Report of Dam Safety Assessment of Coal Combustion  
Surface Impoundments  
Interstate Power and Light Company  
M.L. Kapp Generating Station  
Clinton, IA

AMEC Project No. 3-2106-0183.0002

May 2011

6

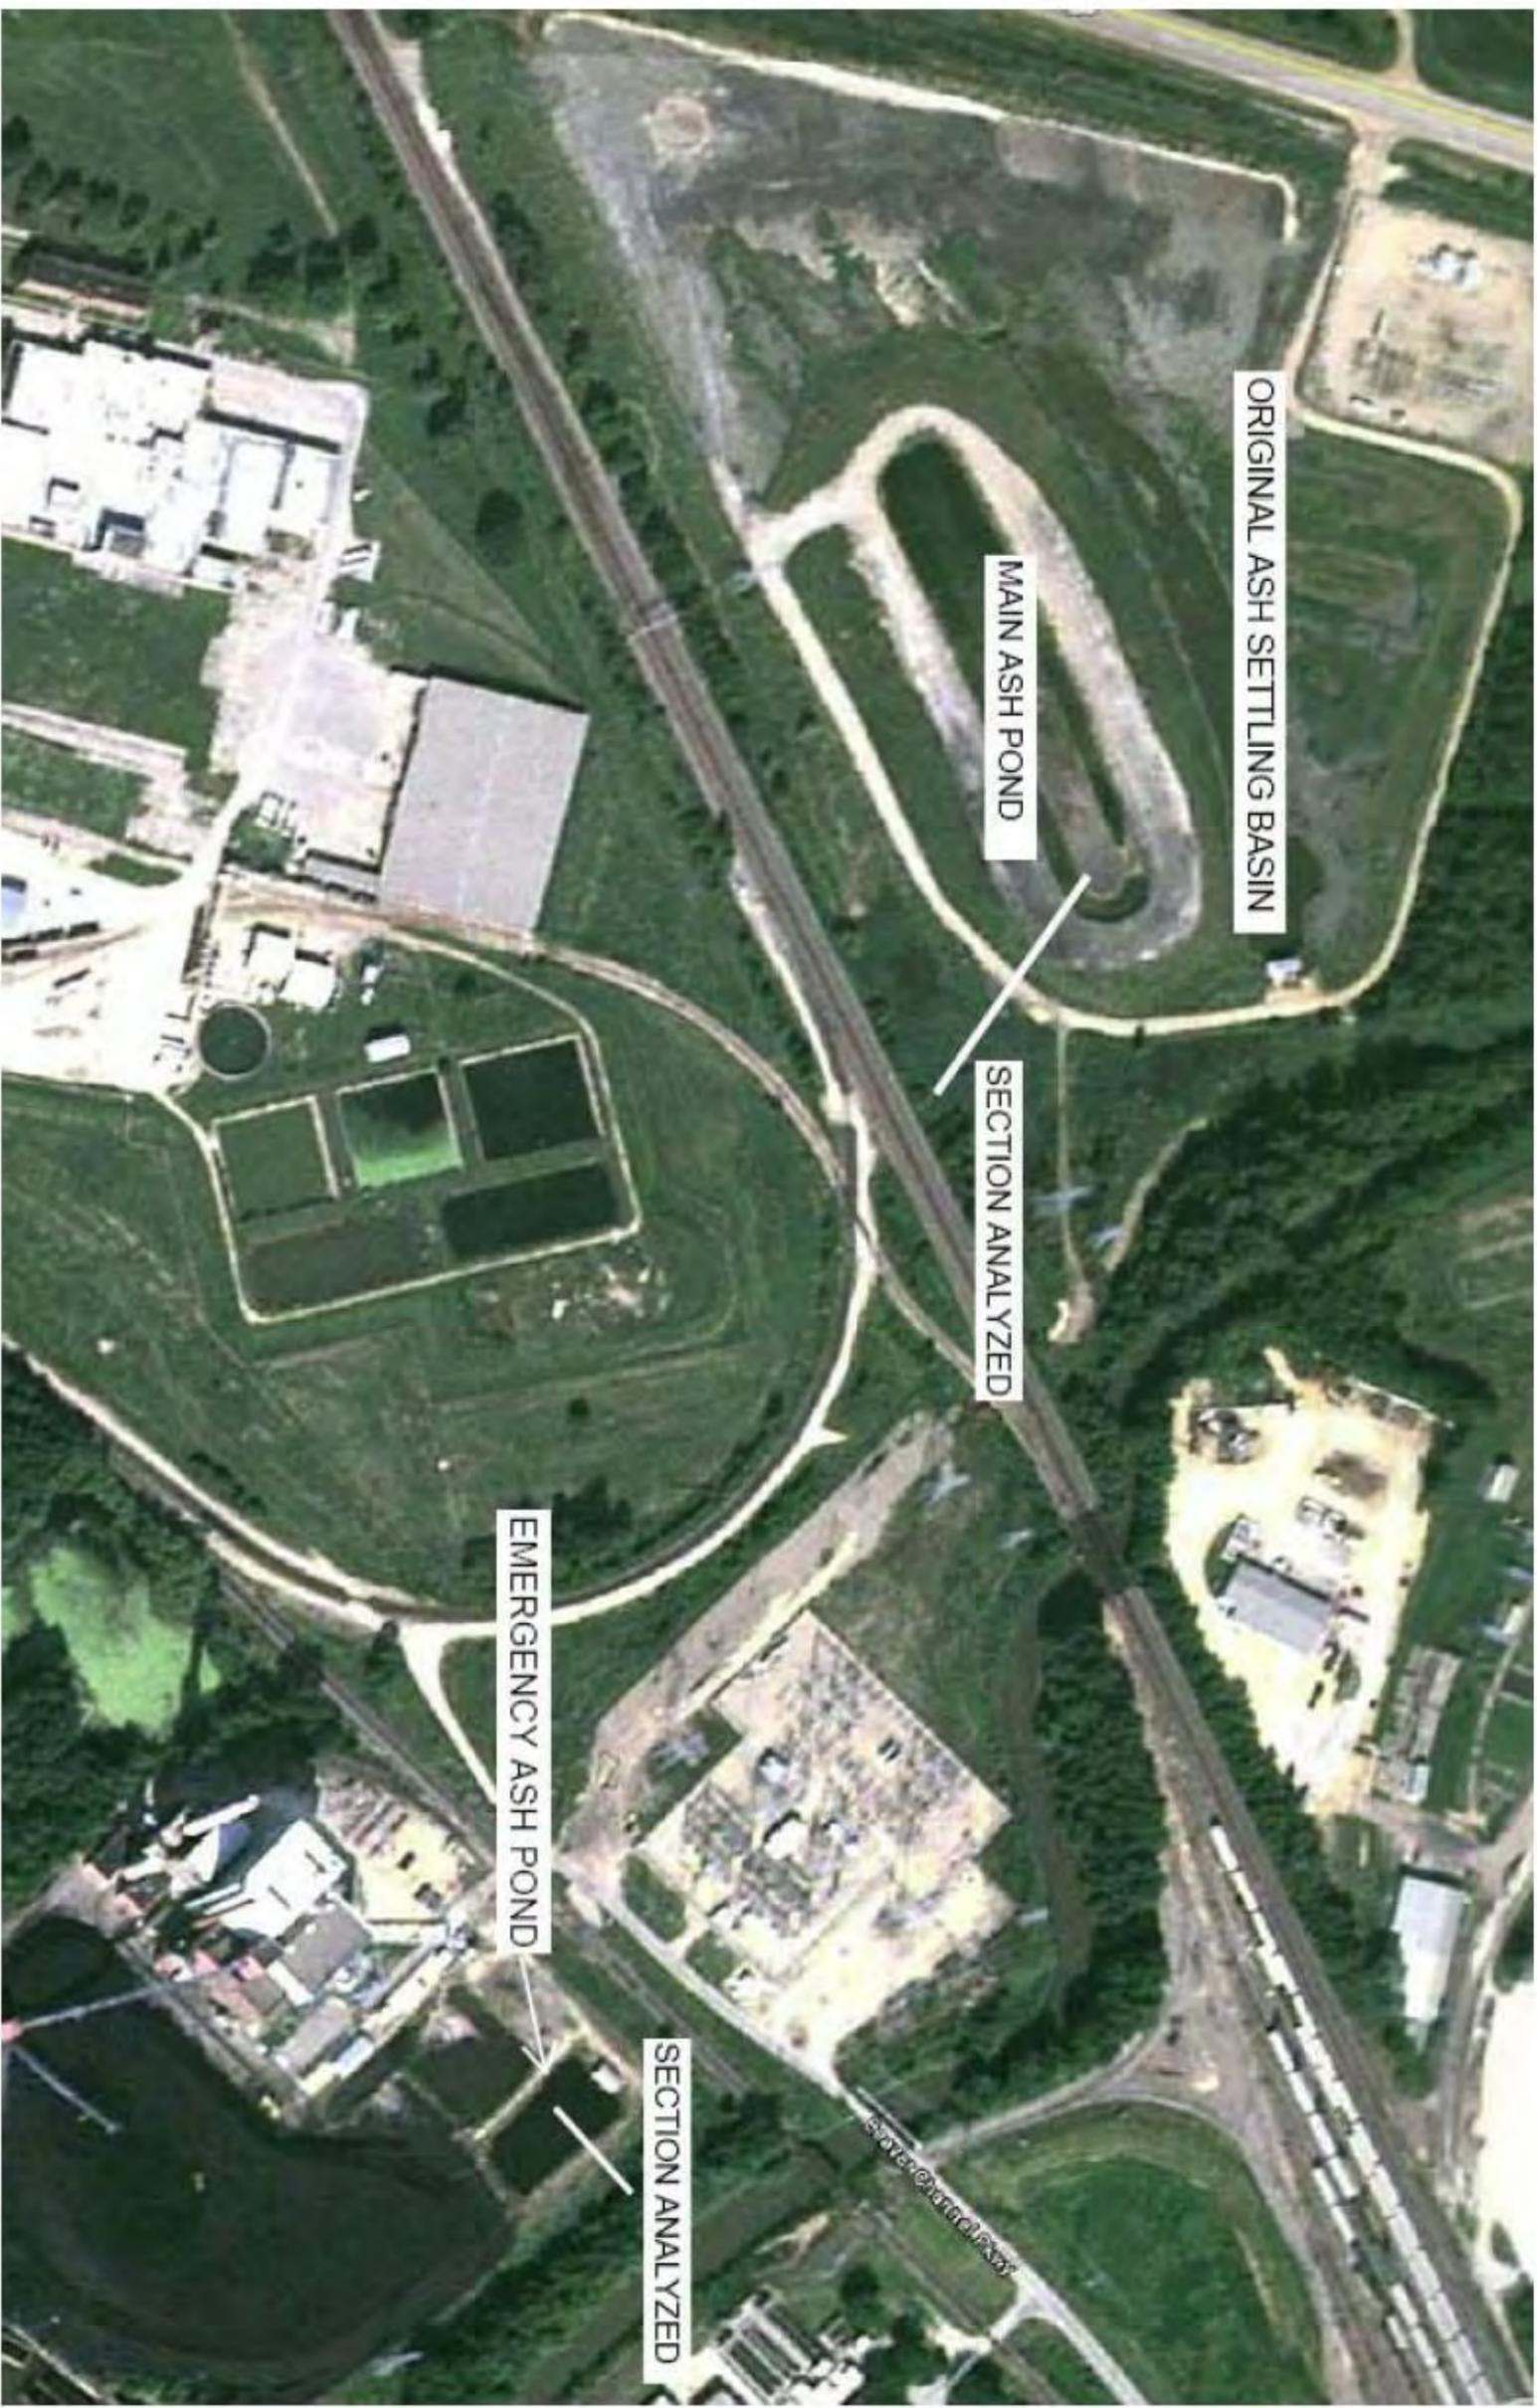
Sargent & Lundy evaluated the overall stability of the dams by reviewing cross sections and previously collected drilling data for their study, as shown on Figure 7. Sargent & Lundy notes the cross sections selected for analysis “were estimated to present the most critical stability conditions for dike stability around the ponds”. The slope stability analyses were performed using SLOPE/W program version 5.211. Minimum acceptable factor of safety (FS) values for the static, seismic and the rapid drawdown conditions analyzed in this calculation were 1.5, 1.15 and 1.1 to 1.3, respectively. Sargent & Lundy stated in their report:

Therefore, Sargent & Lundy’s slope stability analyses included static and seismic (pseudo-static) conditions only for the downstream (exterior) dike face for the Main Ash Pond, and the study included static and seismic (pseudo-static) conditions for the downstream dike face and rapid drawdown condition for the interior face for the Emergency Ash Pond. For their study, Sargent & Lundy utilized the soil borings, B-1 and B-2 performed in 1994 by Huntingdon Engineering & Environmental, located adjacent to the Emergency Ash Pond and Main Ash Pond dikes, respectively. Table 7 and Table 8 provide a summary of the soil properties utilized in Sargent & Lundy’s report. We understand the two borings utilized by Sargent & Lundy for the basis of their slope stability analyses were drilled adjacent to the existing dikes; therefore, we understand the information utilized for the dike material was based on available construction documents.
